Oil Temperature Assembly for the Continentals

SERVICE INFORMATION LETTER

P/N 13340-00 OIL TEMPERATURE GAUGE (FORMERLY REFERRED TO AS RN-2100 OIL TEMPERATURE GAUGE)

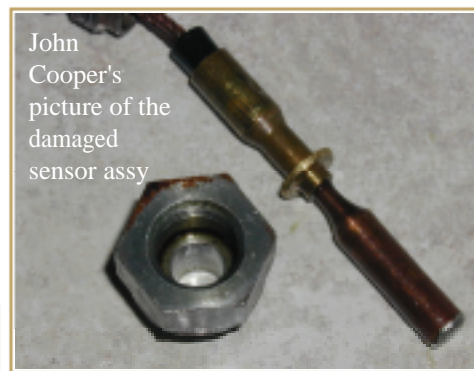
Pictures of the two adapters, with the conical sealing surface on the left and the flat sealing surface on the right. An illusion suggests that the conical surface is larger in diameter, but both surfaces are the same diameter and are the same as the peaks of the threads. Note, too, the difference in surface finish quality. Items from Jim Williams.

The left figure shows the dual adapter set sent to me by Jim to see the two types he had received with two orders, one with the flat internal sealing surface (on the right) and one with the conical sealing surface. It allowed me to confirm what he had said about the poor workmanship which leads to a non-stoppable leak because the sealing surface of the unit on the left undulates because the machinist allowed the tool to chatter. Scott is believed to be checking with their vendor and the design to find out why the wrong combinations and why the poor workmanship. In his discussion with them, it was not established whether the fault lay with a poor spec (the surface flatness not called out) or print, or poor workmanship.

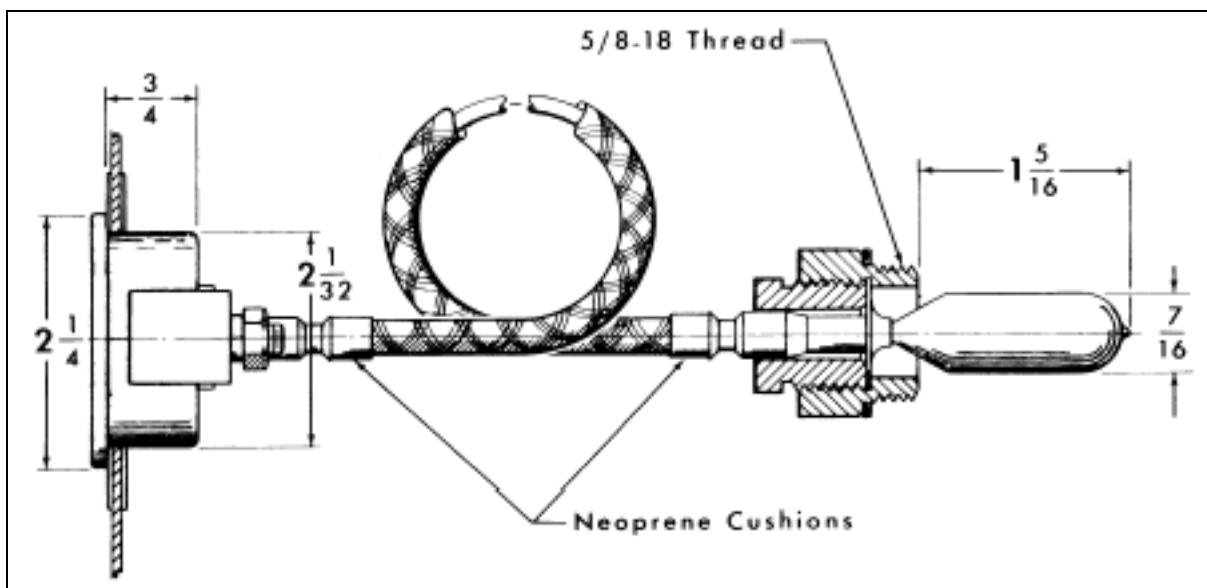
This figure is better than most of Scott's and it comes from the newest Avial parts CD. Note the flat surface areas for sealing between the adapter and the sensor. This is the only figure I know of which has the dimensions, but is incorrect in that the 5/8-18 internal threads and the 5/8-18 external threads should have the same diameters. Sigh. I present it here because of the dimensions, especially that of the meter body diameter, a number often misleading in the catalogs.

Figure 3
Current Conical-Type Flange

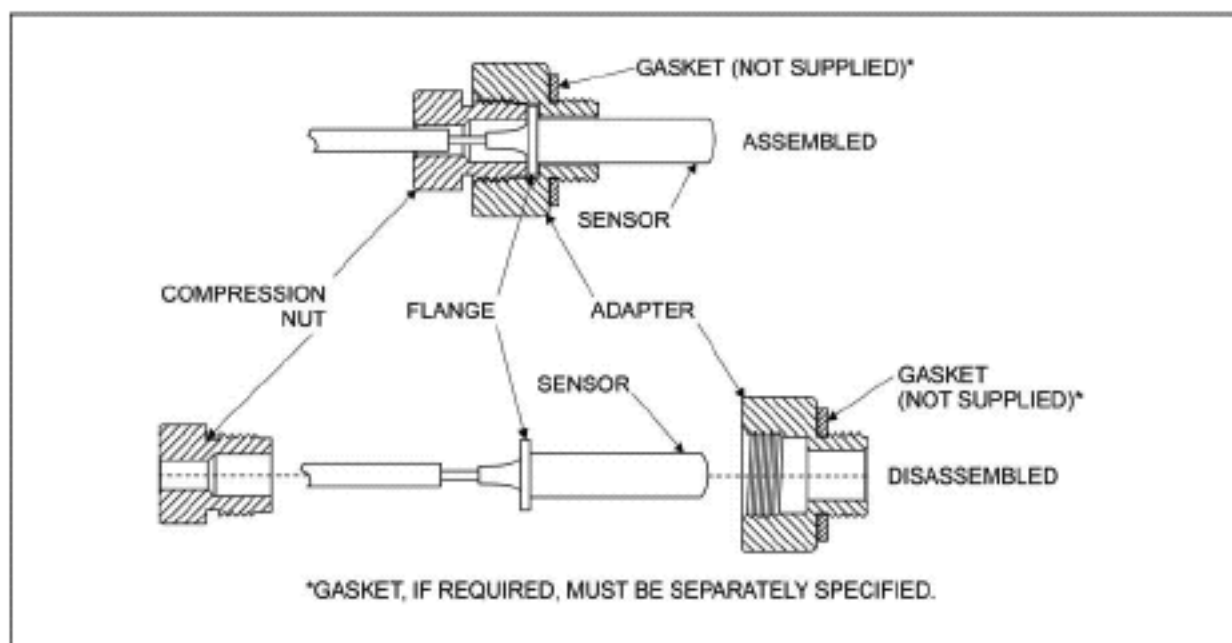
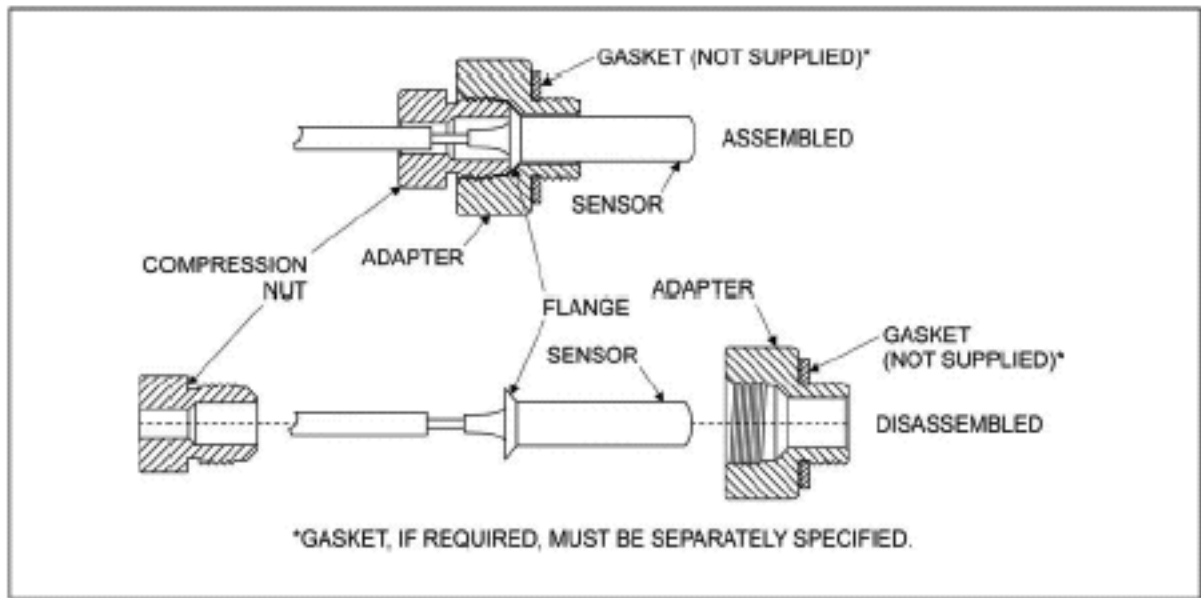
Two different types of oil temperature sensors have been supplied on the 13340-00 gauge. The earlier type, manufactured before 1998, had a flat flange at right angles to the sensor as shown in Figure 2. The current type, manufactured during 1998 and later, has a conical shaped flange on the sensor as shown in Figure 3.

The current design of the gauge has conical mating surfaces as shown in Figure 3. The compression nut and the sensor are assembled at the time of manufacture and cannot be separated. The adapter must be a separate part to accomplish the installation.

If the wrong adapter is installed, the mating surfaces may not seal. For example, if a new gauge is purchased, but the already installed flat-faced adapter is not removed and replaced by the new adapter, then the conical mating surface of the sensor and the compression nut will not seal with the old flat-faced adapter. Installation of a new gauge with a conical flange and compression nut into an old adapter with a flat surface can result in damage to the sensor and loss of engine oil.

When installing a replacement gauge, it is critical that the compression nut, sensor bulb and adapter making up the complete oil temperature gauge be installed together. Make sure to remove the existing adapter from the engine, then install all three new parts.

Refer to the engine manufacturer's manual or maintenance instructions for the correct gasket if a gasket is required. If you find an oil leak at the adapter to compression nut joint and a mismatch is suspected, replace the entire gauge assembly (including the adapter).

REPLACEMENT OF 13340-00 OIL TEMPERATURE GAUGE

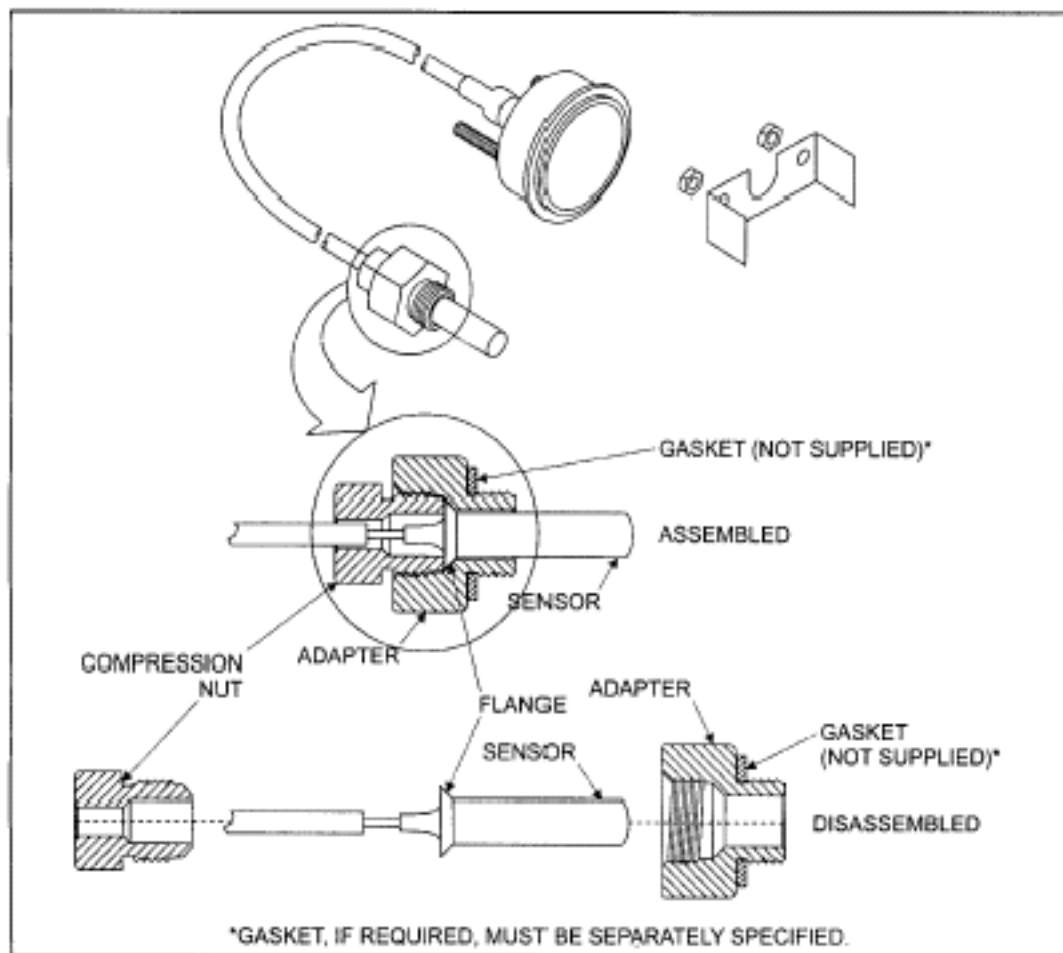
When installing a replacement gauge, it is critical that all the components of the original gauge be replaced. Make sure to remove the existing adapter. When installing the replacement adapter, refer to the aircraft/engine maintenance instructions for the appropriate gasket if required. Torque the new adapter to the engine/aircraft manufacturer's specifications, but not less than 12 to 15 lb ft (16.3 to 20.3 N•m).

Carefully insert the oil temperature bulb into the adapter. After insertion of the bulb, torque the compression nut to the engine/aircraft manufacturer's specifications, but not less than 12 to 15 lb ft (16.3 to 20.3 N•m).

Never attempt to install the sensor directly into an engine without the adapter.
